**SUBJECT:** Duval County Health Department TB Unit Expansion  
Contractor: CORE Construction Company  
Contract No: 8565-07

Forwarded herewith for execution is Change Order No. 24 for subject project.

CHANGE ORDER TRACKING SHEET

Subject: TB Unit Expansion; City Contract No. 8765-07  
PCO #3 -- Electrical work for new panel

PROJECT: <u>TB Unit, Duval County</u>	DATE: <u>6/4/2015</u>
<u>Health Department</u>	
	RFI # <u>19</u>
CONTRACTOR: <u>Core Construction Company</u>	SPEC REF: <u>n/a</u>
CONTRACT/P.O.#: <u>8765-07</u>	DWG REF: <u>Door &amp; Hardware Submittal - Painting</u>

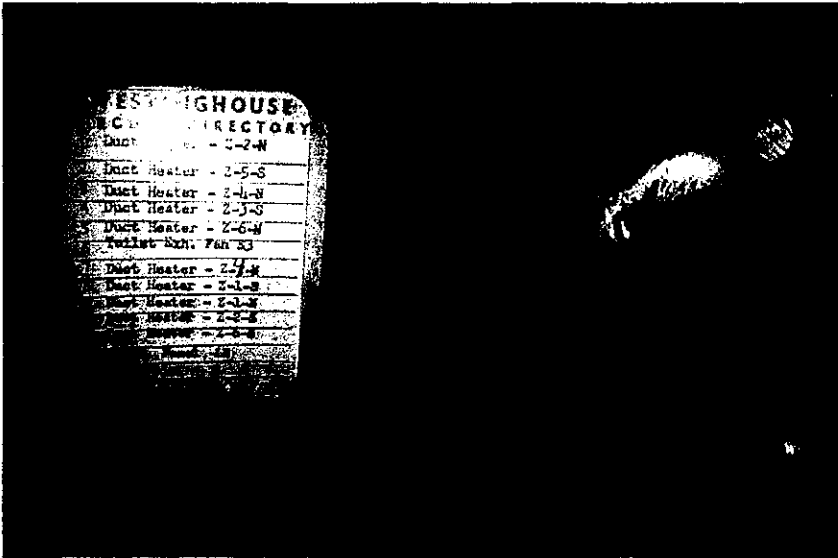
RFI DESCRIPTION: Please review the attached picture of the existing panels. Pics showing existing duct heaters from panel "HP". Panel "HP" is where prints indicate new duct heaters will originate from but it is being used to serve existing duct heaters for the rest of the building. There is no extra space for any new circuits.

Please advise how to provide power to new duct heaters.

A new panel will be added to serve the new duct heaters. Drawing revisions will be issued to show the additional panel.

DUVAL COUNTY DEPARTMENT OF HEALTH  
TB UNIT EXPANSION  
ELECTRICAL SCHEDULES

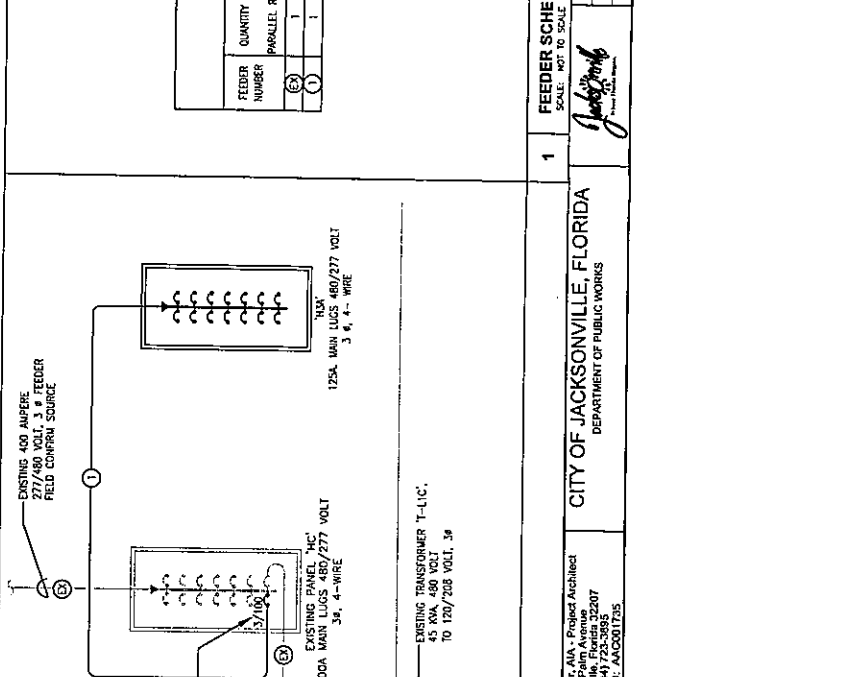
NBR	MASTER ITEM DESCRIPTION	QUANTITY	UOM	UNIT COST	NET ADDITION	NET DELETION	TOTALS
<b>DESIGN ERROR/OMISSION</b>							
1	INSTALL 125 AMP MLO PANEL & BREAKERS, INCLUDE SERVICE FEE FROM THE HC PANEL AND A 3P 100AMP BREAKER AS SHOWN ON THE REVISED PLANS.	1.00	LS	\$7,188.50	\$7,188.50		
<b>TOTAL DESIGN ERROR/OMISSION</b>							<b>\$7,188.50</b>
SUBTOTAL CHANGE ORDER NO. 2					\$7,188.50	\$0.00	
NET TOTAL CHANGE ORDER NO. 2					\$7,188.50

JUSTIFICATION: The original electrical design for the HP panel indicates service for the existing duct heaters. The new duct heaters will originate from this same location; however there is no extra space for any new circuits. A new panel will have to be added to serve the new duct heaters and the drawings modified to reflect the same.

- ① REMOVE EXISTING SPARE CIRCUIT BREAKER AND PROVIDE AND INSTALL A 3 POLE, 100 AMPERE, 14,000 AC CIRCUIT BREAKER IN REMAINING SPACE. BREAKER TO BE FULLY COMPATIBLE WITH THE WESTINGHOUSE TYPE 'MENS' PANELBOARD.
